Reviewer 1

This paper presents an analysis of the runoff contribution, past, present and future, of glaciers in the western Kunlun Shan depending on which of the two currently available global ice-thickness datasets is used to initialise the ice-flow model (OGGM). The authors find substantial differences in the timing of peak water depending on the dataset used, as well as the meteorological forcing used for the future portion of the simulations. I think this is a well-executed paper that fits the format of a brief communication. The method is solid and the findings well-supported, meaning the paper provides a nice illustration of the importance of model initial conditions in an under-studied region. I have a few minor comments that should be fairly easy to fix, so I recommend the paper be returned to the authors for minor revisions.

Temperature and precipitation in the region under GCM CanESM5 under SSP1-2.6 (blue), SSP5-3.4-OS (yellow) and SSP5-8.5 (red).

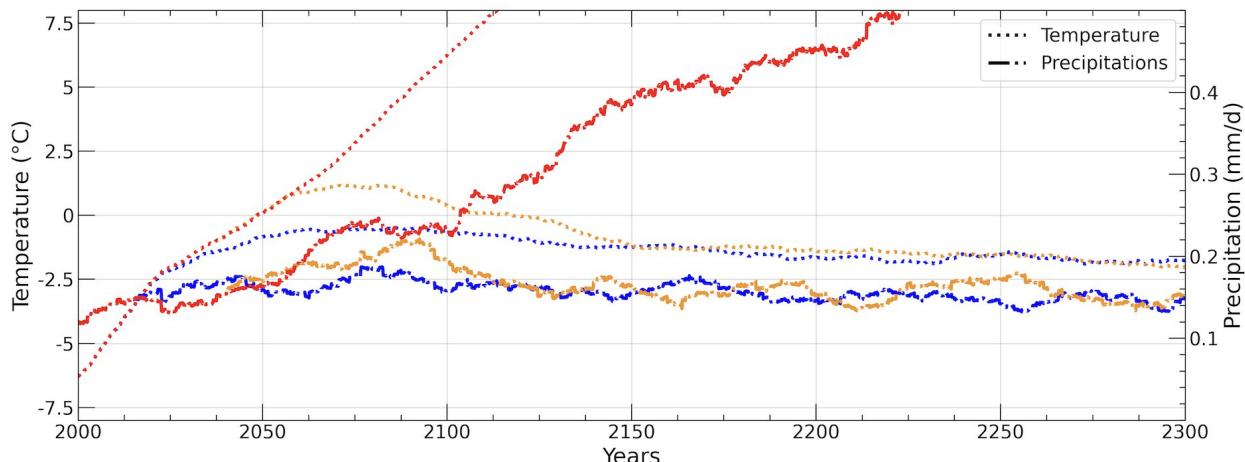
- p.7, Section 2.6: OK, fair enough, the study is only interested in the difference caused by the initial ice thickness, but there needs to be an extra line here to explain why the authors picked that one particular GCM out of the several available.

Authors: Agreed. In the revised version we now use 5 different GCMs. Out of the 5 GCMs available in OGGM that extend until 2300, one (CanESM5) was put aside because presenting very sharp temperature increase in the region (see figure below).
